Regulation No. 86 (Installation of lighting and light-signalling devices for agricultural tractors)**Proposal for 01 Series of amendments to Regulation No. 86 (Installation of lighting and light-signalling devices for agricultural tractors)****Submitted by the Chair of the Informal Working Group on Agricultural Vehicles Lighting Installation***

The text reproduced below was prepared by the GRE Informal Group "Agricultural Vehicles Lighting Installation" (AVLI), to update and revise Regulation No. 86. It is based on the document E/ECE/324/Rev.1/Add.85/Rev.1 **((to be updated depending on further results of WP.29 and GRE))**. The modifications to the current text of the UN Regulation are marked in bold for new or strikethrough for deleted characters.

"Uniform provisions concerning the approval of agricultural or forestry vehicles ~~tractors~~ with regard to the installation of lighting and light-signalling devices

Model A
(See paragraph 4.4. of this Regulation)

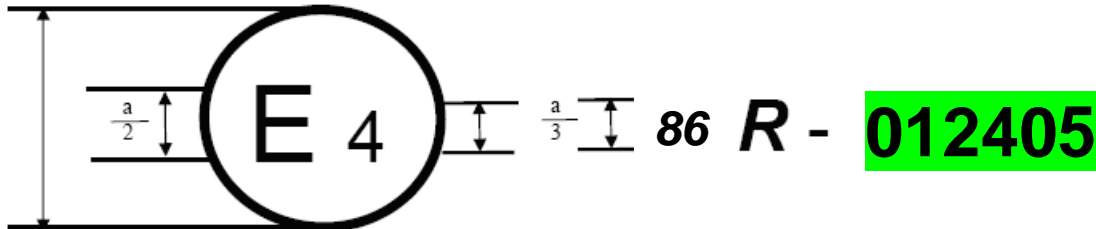
The above approval mark affixed to an agricultural or forestry ~~vehicle tractor~~ vehicle shows that the ~~vehicle tractor~~ vehicle type concerned has, with regard to the installation of lighting and light-signalling devices, been approved in the Netherlands (E 4) pursuant to Regulation No. 86. The approval number indicates that the approval was granted in accordance with the requirements of Regulation No. 86 **in its original form as amended by the 01 series of amendments**.
